SUBJECT: ISSUANCE OF AMENDMENT NO. 29 TO FACILITY OPERATING LICENSE
NO. NPF-41, AMENDMENT NO. 16 TO FACILITY OPERATING LICENSE
NO. NPF-51, AND AMENDMENT NO. 4 TO FACILITY OPERATING LICENSE
NO. NPF-74, FOR THE PALO VERDE NUCLEAR GENERATING STATION, UNITS
1, 2 AND 3, RESPECTIVELY, (TAC NOS. 66798, 66799 AND 66800)

The Amendments revise Section 6 of the Technical Specifications for each of the three Palo Verde Units to incorporate changes reflecting a revised organizational structure for the Palo Verde plant.

SAFETY EVALUATION BY THE OFFICE OF NUCLEAR REACTOR REGULATION
RELATED TO AMENDMENT NO. 29 TO FACILITY OPERATING LICENSE NO. NPF-41,
AMENDMENT NO. 16 TO FACILITY OPERATING LICENSE NO. NPF-51
AND AMENDMENT NO. 4 TO FACILITY OPERATING LICENSE NO. NPF-74
ARIZONA PUBLIC SERVICE COMPANY, ET AL.
PALO VERDE NUCLEAR GENERATING STATION, UNIT NOS. 1, 2 AND 3
DOCKET NOS. STN 50-528, STN 50-529 AND STN 50-530

OFFSITE ORGANIZATION
Figure 6.2-1

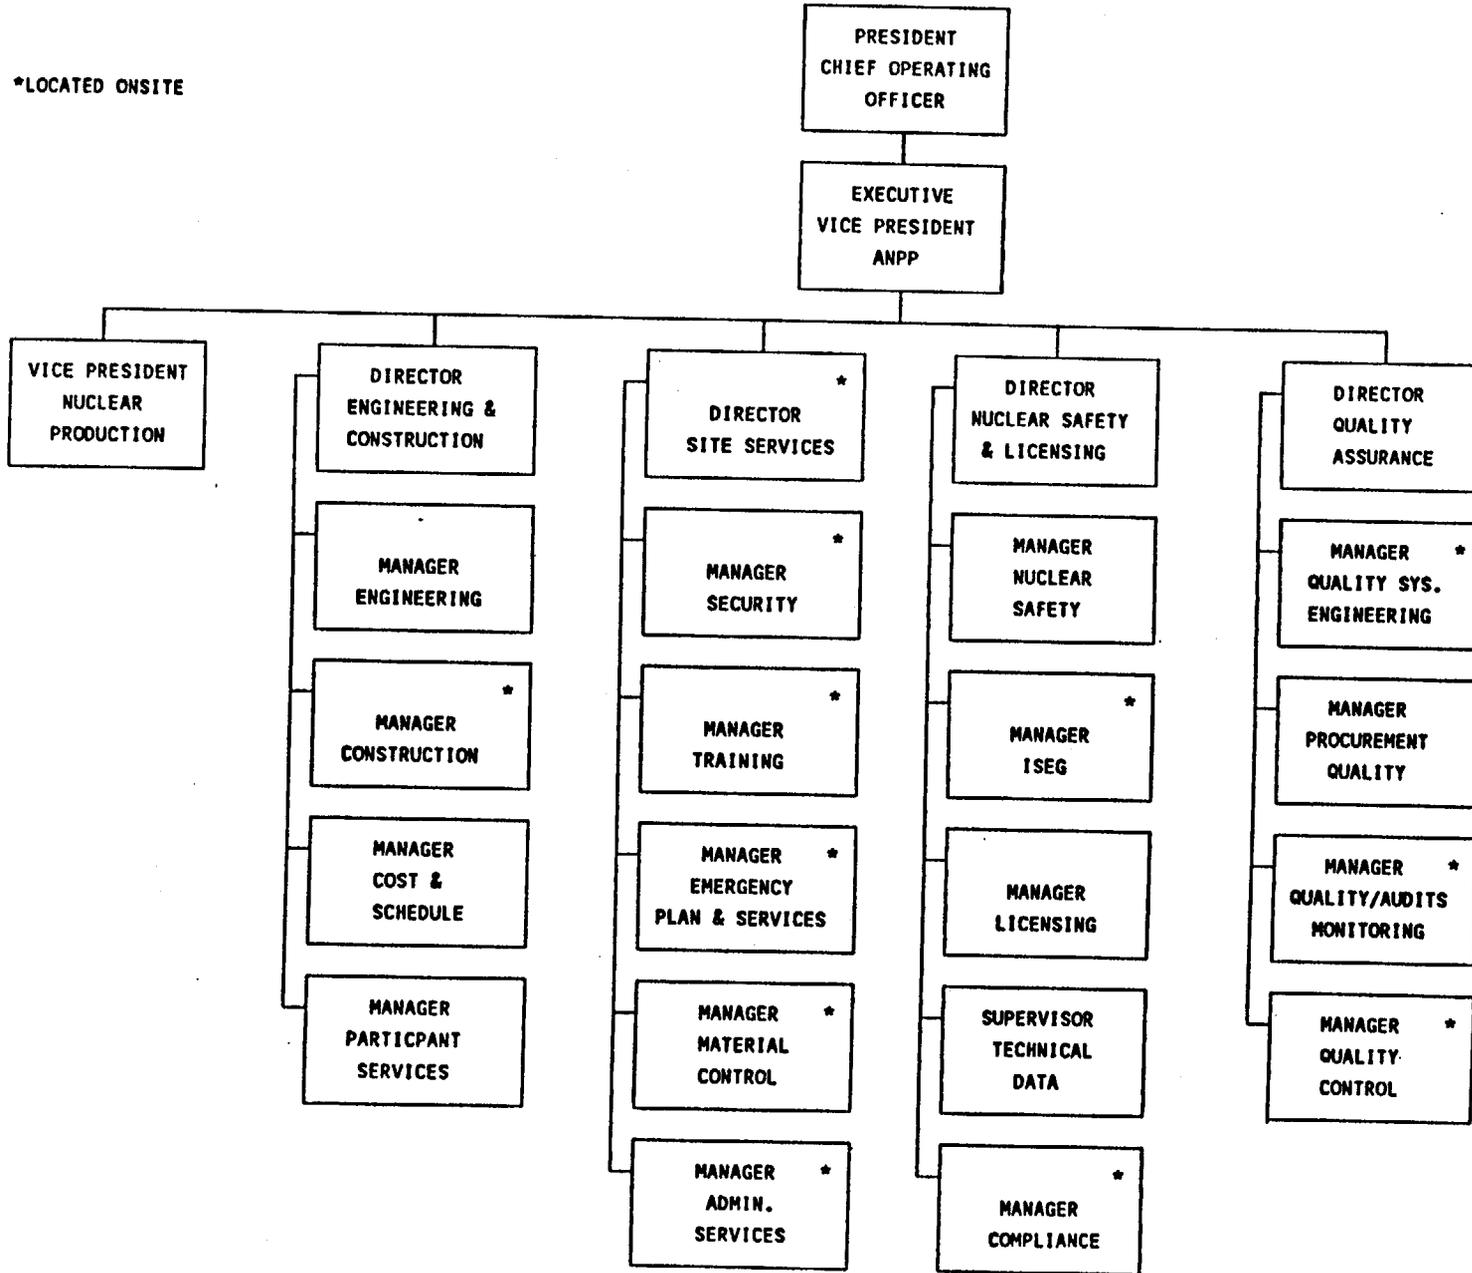
The proposed change requests an amendment to the Palo Verde Units 1, 2 and 3 Technical Specifications, Section 6, Figures 6.2-1 and 6.2-2, "Offsite Organization" and "Onsite Unit Organization." The change is administrative in nature in that the Manager of Nuclear Fuels will now report to the Vice President of Nuclear Production in lieu of reporting to the Director of Engineering and Construction. The change is intended to facilitate communications between the management of the Arizona Nuclear Power Project and the nuclear fuel supply vendor.

The staff has evaluated the proposed change and finds that the change should enhance management effectiveness with regards to fuel management. The Nuclear Fuels Department is responsible for fuels management and core analysis for the Palo Verde Units. The Manager of Nuclear Fuels provides nuclear fuel design, contracting and utilization expertise, nuclear fuel core and plant transient and accident analysis, and alternative core operating strategies. The areas of responsibility will remain the same.
